The Release Note 3 MP Incident Detection Camera V5.1.6

Firmware	Firmware Version:	V5.1.6 230423
Basic	Encoding Version:	V2.1 build 230407
Information	Web Version:	V5.1.6.46086 build 230413

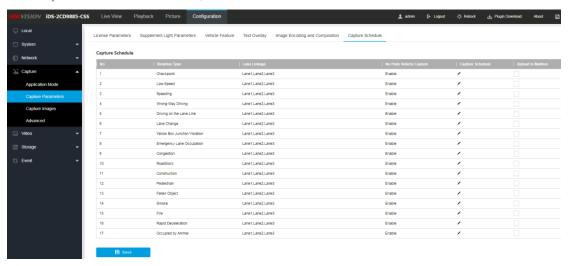
1. Support the country configuration of Serbian license plate recognition;

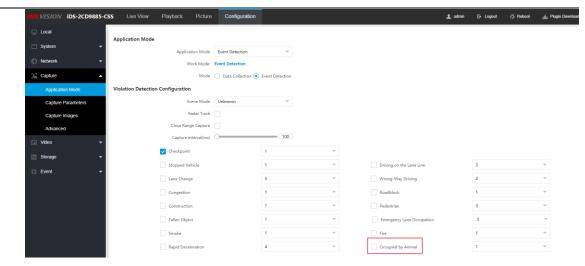
- 2. The ONVIF protocol supports profiles;
- 3. Add capture schedule function;

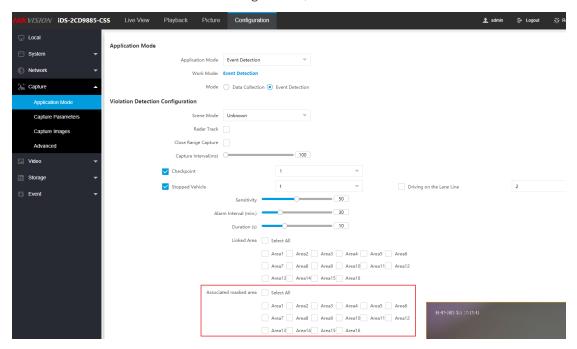
4. Add occupied by animal function;

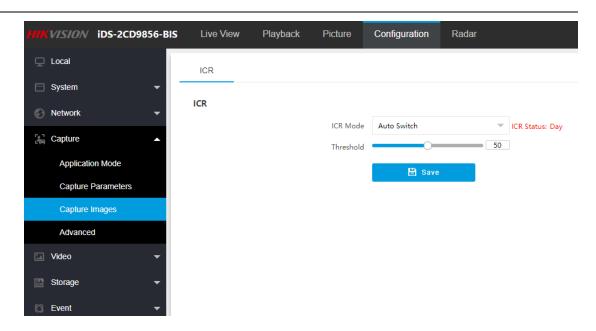
5. Add the associated masked area configuration;

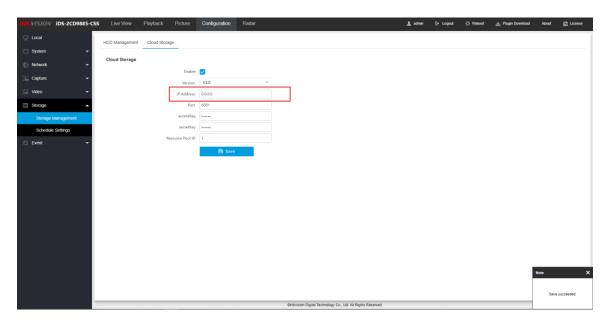
- 6. ANPR adds the upload ADRNO field;
- 7. The current ICR status is displayed during auto switch;

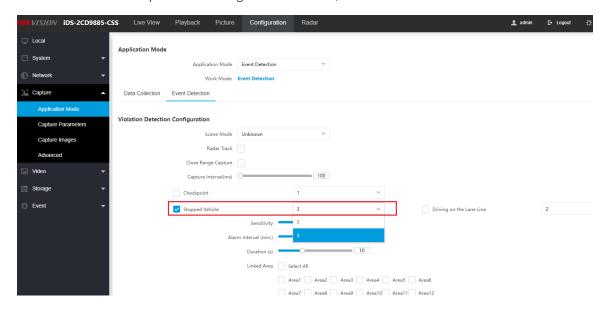
- 1. Optimize license plate brightness compensation (FBL) logic;
- 2. The configuration of Stopped Vehicle capture is changed from 1-3 to 2-3, and the default number of captures is changed from 1 to 3;
